Access Compliance Report Public Rights-of-Way (Curb Ramps)

Intersection ID: 20495 Main Street: BRIDLE_STONE_CT Cross Street: STEELECHASE_DR Location: NW

ADA ID: 744625B3C17B Ramp Type: PerpDiag Initial Pass/Fail: Fail Overall Compliance: No Severity Score: 12.5

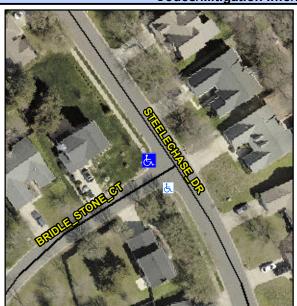
Remove & Replace Curb Ramp With
Two New Directional Ramps or
Equivalent.

PROW/ADA:
R304.2.2

Comp	liance Descripti	on	Data	Comp	liance	Description	Data
N/A	Ramp Length (in)		99.0	No	Ram	Slope (%)	8.6
Yes	Ramp Width (in)	1	48.0	Yes	Ram	XSlope (%)	1.1
N/A	Flare Type LT		N/A	N/A	Flare	Type RT	N/A
N/A	Flare Slope LT (%)	N/A	N/A	Flare	Slope RT (%)	N/A
N/A	Flare Traversabl	le LT?	N/A	N/A	Flare	Traversable RT?	N/A
N/A	Landing Length	(in)	N/A	N/A	DWS	Provided?	N/A
N/A	Landing Width (i	n)	N/A	N/A	DWS	Contrast?	N/A
N/A	Landing Slope (9	%)	N/A	N/A	DWS	Length (in)	N/A
N/A	Landing X Slope	e (%)	N/A	N/A	DWS	Full Width?	N/A
N/A	Landing Curb? (Y/N)	N/A	N/A	DWS	Offset (in)	N/A
N/A	Shared Landing	?	N/A				
N/A	Gutter Ponding?	>	N/A	N/A	Gutte	er Slope (%)	N/A
N/A	Gutter Lip Ht (in))	N/A	N/A	Gutte	er X Slope (%)	N/A
N/A	Painted X Walk1	!?	No	N/A	Paint	ed X Walk2?	No
	X Walk 1 Direction	on	To SE		X Wa	lk 2 Direction	To NE
N/A	X Walk 1 Width ((in)	N/A	N/A	X Wa	lk 2 Width (in)	N/A
	X Walk 1 Slope ((%)	1.6		X Wa	lk 2 Slope (%)	1.9
